UNITED STATES PATENT AND TRADEMARK OFFICE

Office Action Summary

10/621,249

SEKINE, TOMOHIRO

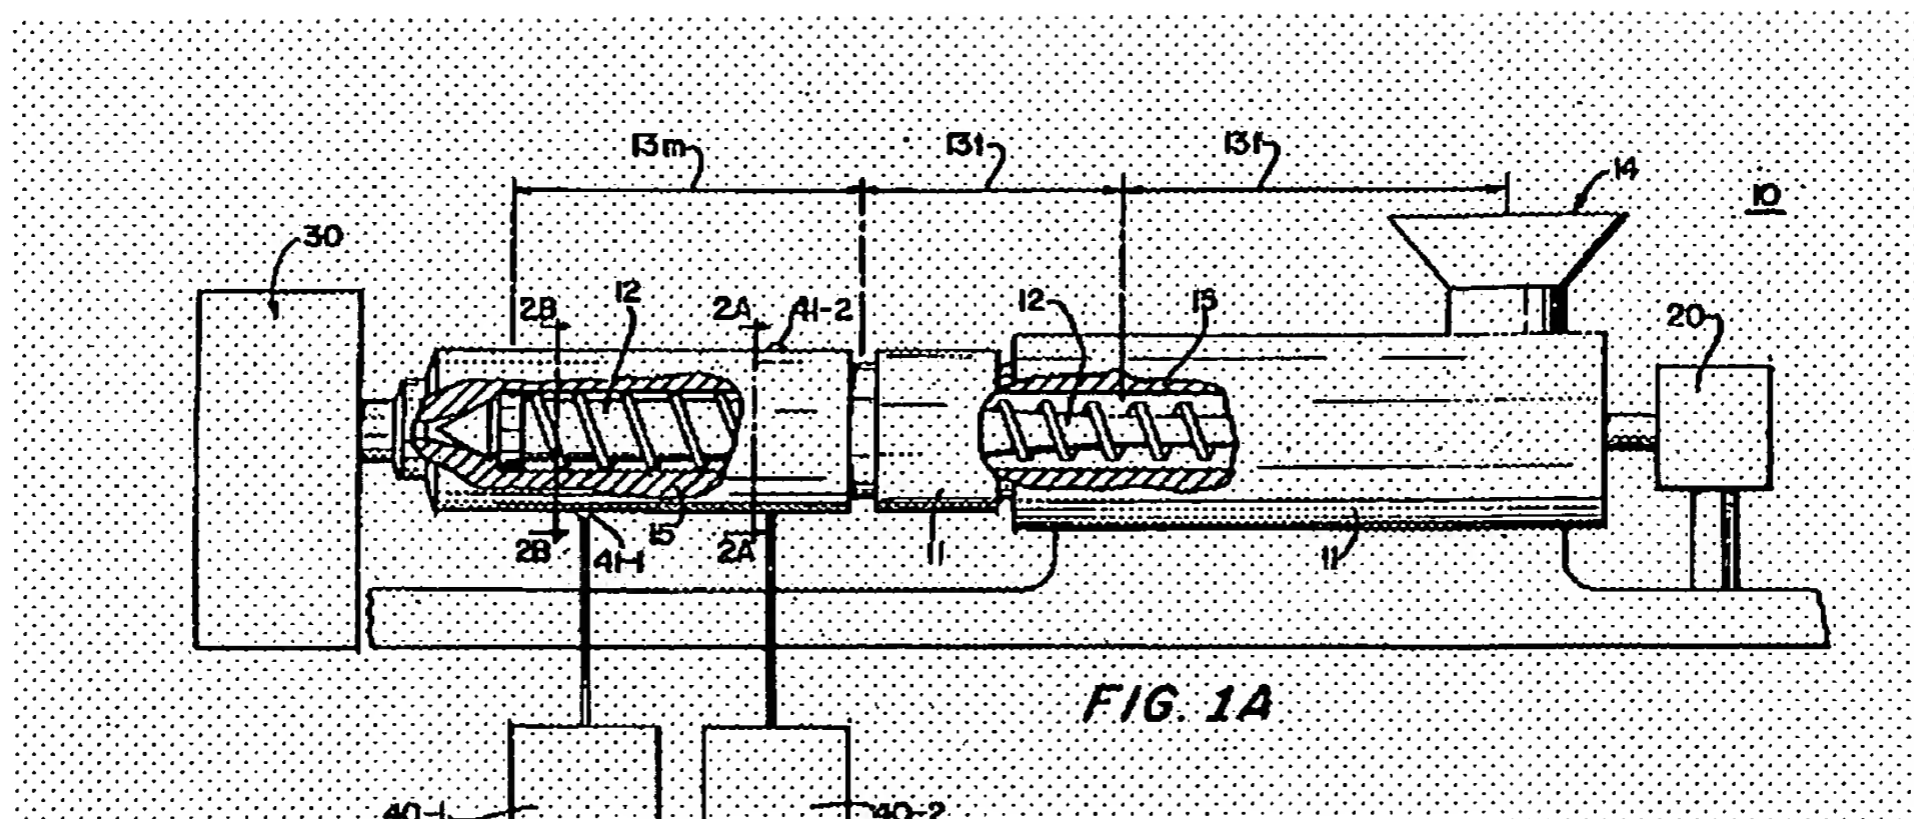
3. In this instance the applicants show a wood grained pattern in the drawings and also describe the formation a wood grained product. However, these instructions are very basic. A wood grained pattern involves the formation of both concentric rings and linear lines (the drawing shows concentric rings); the application fails to describe the method in a way to show that the applicant possessed the claimed invention.

7. It is not clear what the applicants mean by wood grain; since this is a faux finish it is not clear if the mere difference between a marbleized finish and a wood grain finish is merely a difference in color or actual type of streaking. The specification does not really differentiate the process of forming the two.
